3 Pigeon Mountain Road - BUN60419132

Further to our discussions, please see the following comments in relation to the residual matters pertaining to the above resource consent application.

S92 RESPONSE

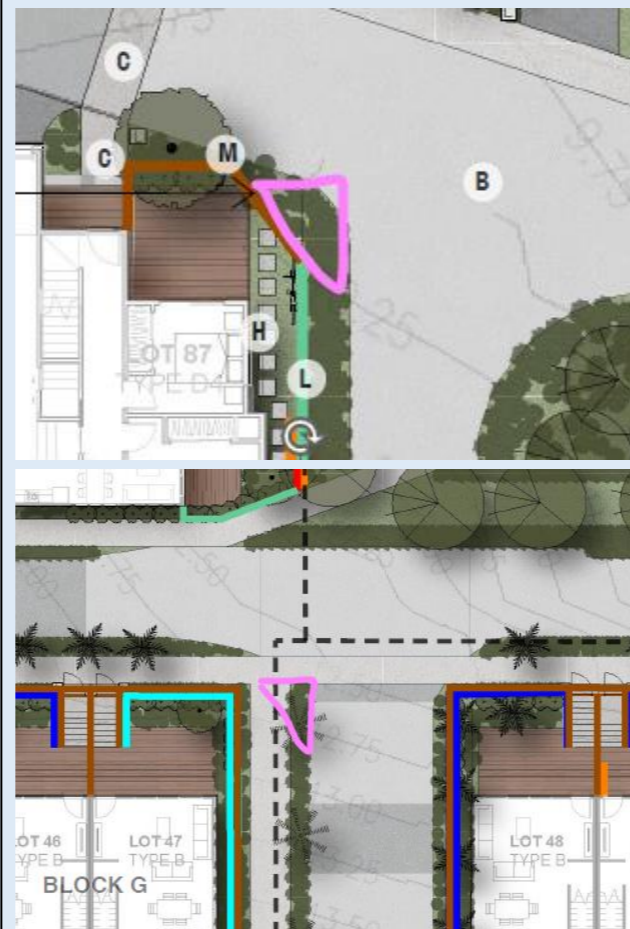
See additional assessment plans by TPC.

Fencing and landscaping has been revised in these areas.

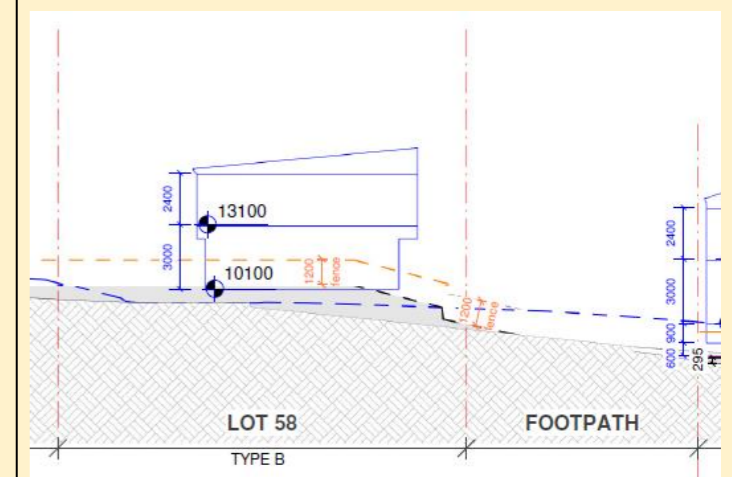
On the RTW elevation on sheet RA1316, the blue dashed line represents the height of the existing retaining wall. The grey shaded area represents the height of the proposed retaining wall. The orange dashed line represents a 1.2m high proposed fence. As shown, for the majority of the frontage along PMR, the height of the combined proposed retaining and fencing is a similar to height of the existing retaining wall.

The section of retaining wall adjoining Lot 58 is slightly higher than existing, however it is noted that the proposal also removes a section of existing retaining wall where the pedestrian entry is proposed to be.

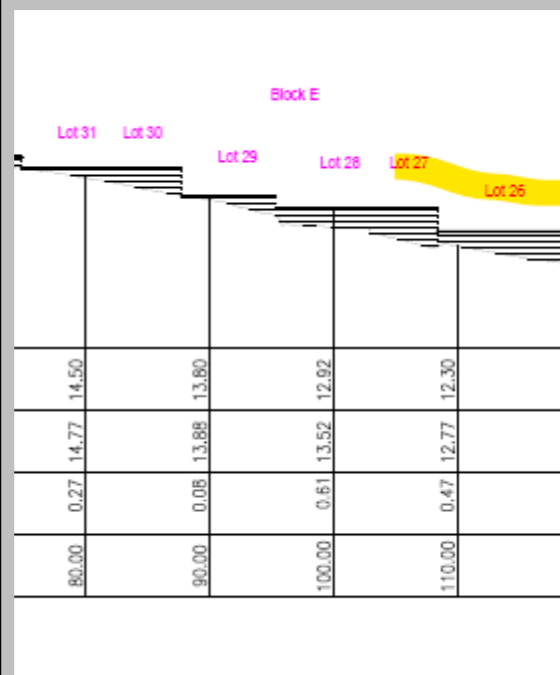
24 Please clarify the height of the retaining walls adjacent to Units 25 to 27. While the AEE and Drawing RA0104 specifies these are a maximum of 1.0 m, Sheet 200 (where the units are numbered 24 to 26) shows that over 1 m of fill earthworks are proposed behind these walls.

Please refer updated page 204a for the updated retaining wall heights.

Sufficient information has been provided in response to this request. However, please note the request under item 1 for Drawing RA0104 to be consistent with the retaining wall heights specified on Sheets 204 and 204a.

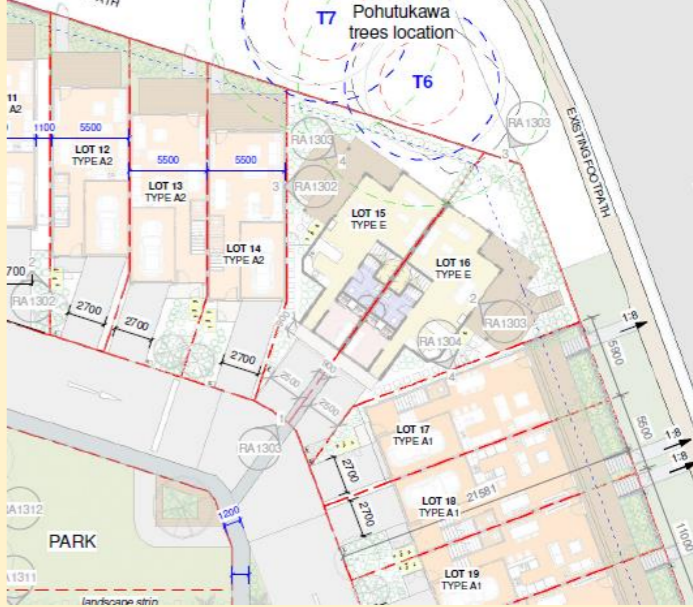
The following previous comments were also provided as to why Lot 15 and 16 cannot be lowered like 17-23:

For Lot 17-23, we were able to just lower the living room, however for Lot 15-16, essentially the whole dwelling would need to be lowered (with many stairs down from the JOAL side) and gravity WW discharge is not achievable, with the dwelling being lower.

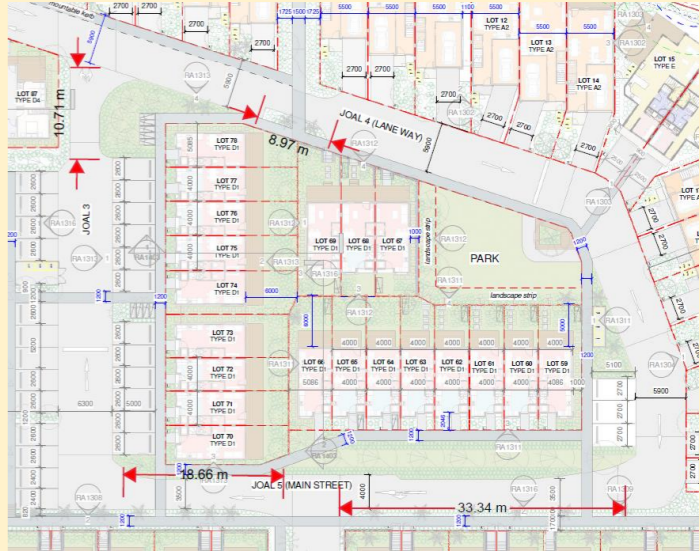
57 Please provide a lighting plan prepared by suitably qualified lighting engineer to demonstrate that consistent and uniform lighting is proposed at communal areas where people movement is expected. JOAL and the common access areas need to ensure safe access after dark, as required under Standard E27.6.3.7. AUP recommends that lighting for pedestrian areas should be calculated in accordance with AS/NZS1158 series of standards and that is following Chapter E24 Lighting of the AUP (OP).

Updated lighting plan to be provided.

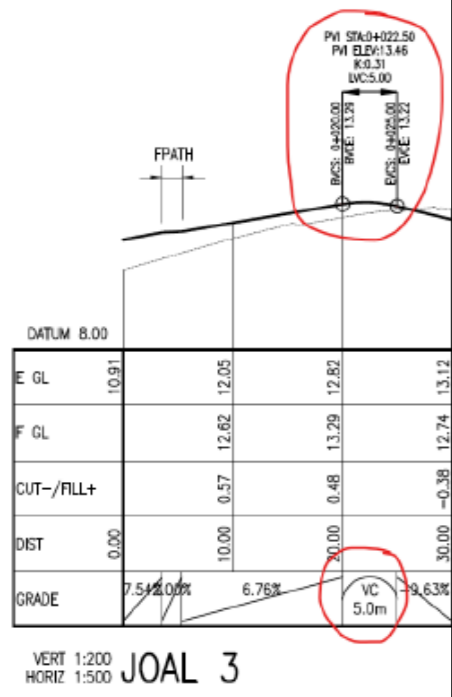
59	<p>Please clarify whether the following transition within JOAL 3 complies with Standard E27.6.4.4(2). If an infringement is identified, please provide the relevant assessment of environmental effects associated with this (including any positive effects compared to a compliant transition).</p>	<p>TPC - Transitions within the site will be provided in all areas necessary and gradient changes will not be greater than 12.5%. This is consistent with E27.6.4.4 (2).</p>	<p>This request is no longer relevant following changes to the gradient of JOAL 3 (the change in gradient at summit is now less than 12.5%).</p>
